Access Compliance Report

Public Rights-of-Way

Intersection ID: 52919	Main Street: HOOVER_CREEK_BV	Cross Street: WALKER_BRANCH_DR	Location: NW
ADA ID: 9D9ECB8D3B30	Ramp Type: Perp	Initial Pass/Fail: Fail	Overall Compliance: No
		Severity Score: 22.5

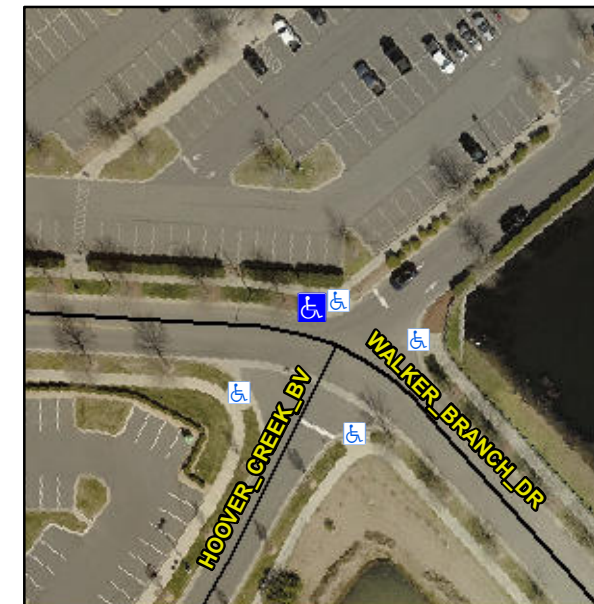
Not Found, R304.5.1, R304.2.2

Compliance	Description	Data	Compliance	Description	Data
N/A	Ramp Length (in)	93.0	No	Ramp Slope (%)	8.8
No	Ramp Width (in)	47.0	Yes	Ramp XSlope (%)	2.2
N/A	Flare Type LT	N/A	N/A	Flare Type RT	N/A
N/A	Flare Slope LT (%)	N/A	N/A	Flare Slope RT (%)	N/A
N/A	Flare Traversable LT?	N/A	N/A	Flare Traversable RT?	N/A
N/A	Landing Length (in)	N/A	N/A	DWS Provided?	N/A
N/A	Landing Width (in)	N/A	N/A	DWS Contrast?	N/A
N/A	Landing Slope (%)	N/A	N/A	DWS Length (in)	N/A
N/A	Landing X Slope (%)	N/A	N/A	DWS Full Width?	N/A
N/A	Landing Curb? (Y/N)	N/A	N/A	DWS Offset (in)	N/A
N/A	Shared Landing?	N/A			
N/A	Gutter Ponding?	N/A	N/A	Gutter Slope (%)	N/A
N/A	Gutter Lip Ht (in)	N/A	N/A	Gutter X Slope (%)	N/A
N/A	Painted X Walk1?	No	N/A	Painted X Walk2?	N/A
	X Walk 1 Direction	To SW		X Walk 2 Direction	N/A
N/A	X Walk 1 Width (in)	N/A	N/A	X Walk 2 Width (in)	N/A
	X Walk 1 Slope (%)	2.6		X Walk 2 Slope (%)	N/A
	X Walk 1 X Slope (%)	2.7		X Walk 2 X Slope (%)	N/A

Remove & Replace Entire Ramp.
